Maine Yankee

Subject: Changes to the Maine Yankee ISFSI Emergency Plan under 50.54(q)

Pursuant to 10 CFR 50.4, please find enclosed Change Numbers 09-01 through 09-13 to the Maine Yankee ISFSI Emergency Plan. These changes have been made in accordance with the provisions of 10 CFR 50.54(q).

SUMMARY OF MAINE YANKEE ISFSI EMERGENCY PLAN (IEP) CHANGES

FIGURE 2-2
MAINE YANKEE SITE
FACILITY LAYOUT

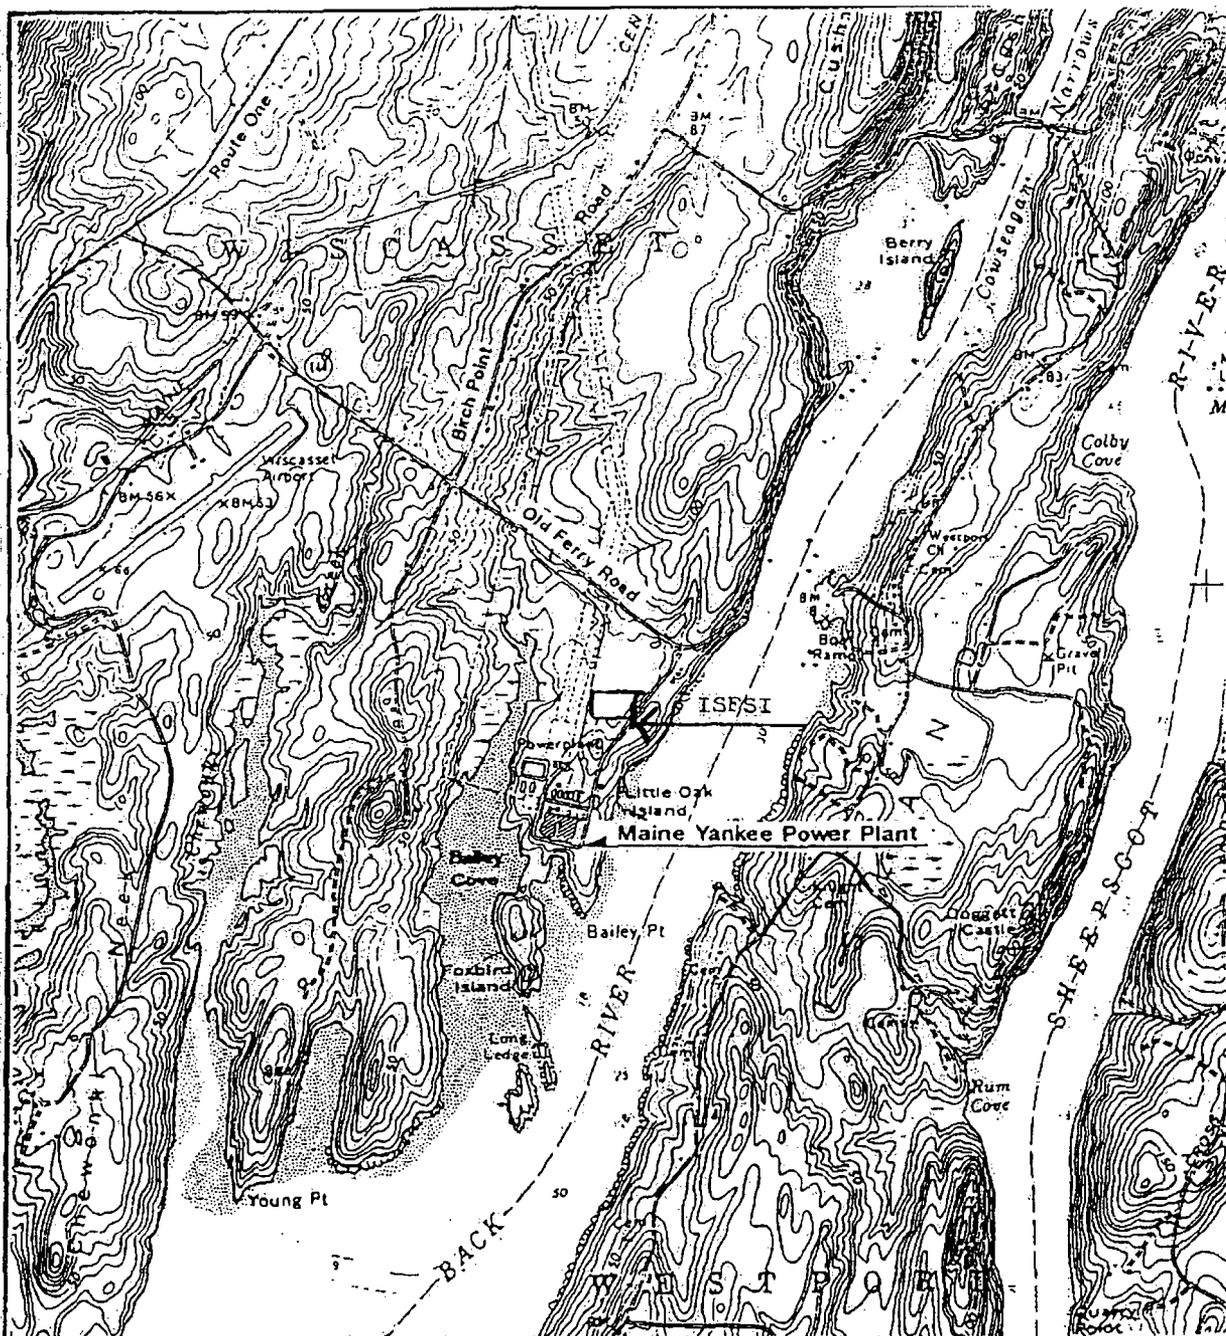
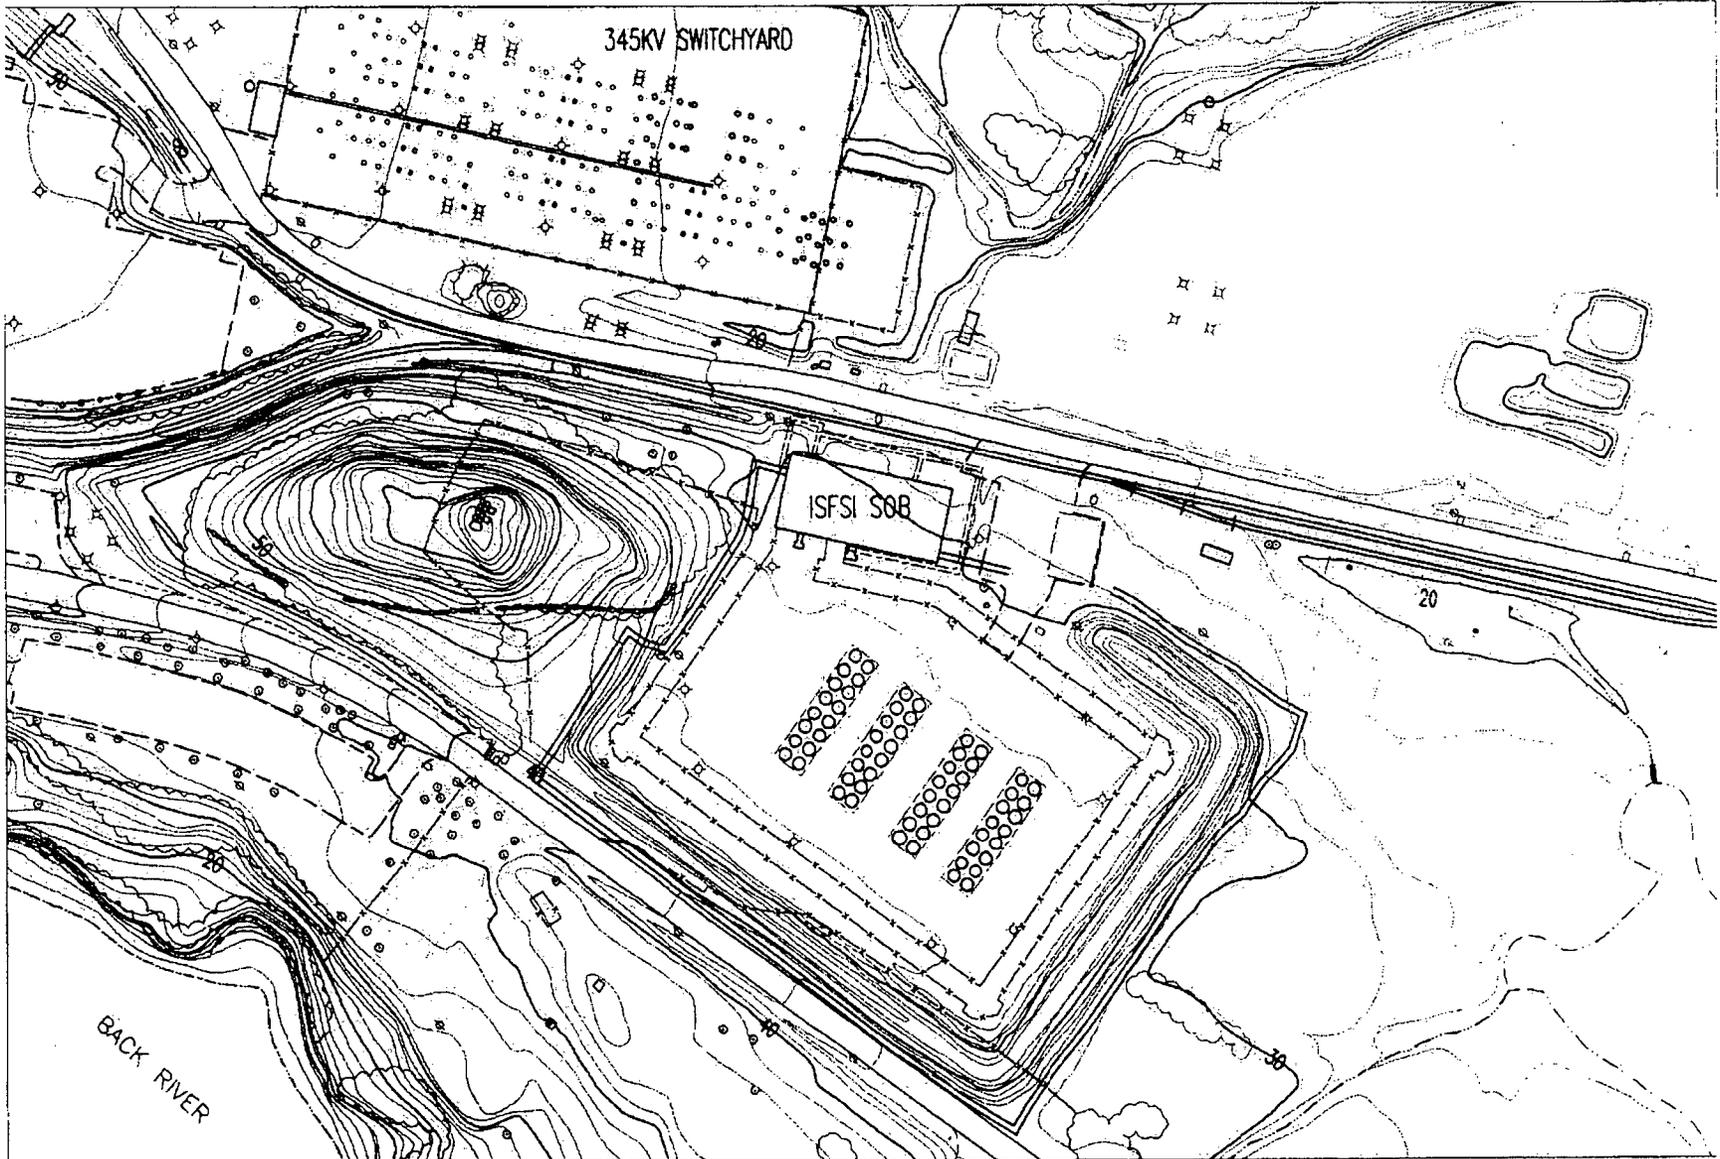
- Page List Deleted page list because the current and all future revisions will be entire revisions and not page changes.
- 2.3 Added the Locker Rooms and Records Vault to the SOB description.

#09-03 Updated the SOB description by adding the new Locker Rooms and Records Vault which were recent modifications. *(2.3)*

**FIGURE 7-1
MAINE YANKEE ISFSI
MINIMUM ON-SHIFT EMERGENCY ORGANIZATION**

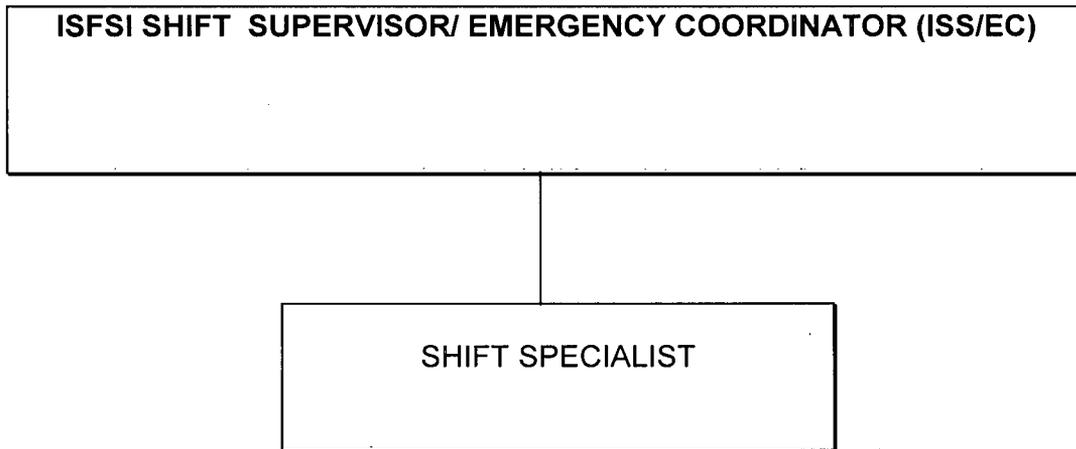
- 7.2 Added “ISS/EC” versus “SS/EC” to be consistent with site procedures, plans, programs.
- Figure 7-1 Added “ISFSI” to Shift Supervisor title, “ISS/EC” versus “SS/EC” to be consistent with site procedures, plans, programs.

- 7.2 Added "ISS/EC" versus "SS/EC" to be consistent with site procedures, plans, programs.
- Figure 7-1 Added "ISFSI" to Shift Supervisor title, "ISS/EC" versus "SS/EC" to be consistent with site procedures, plans, programs.
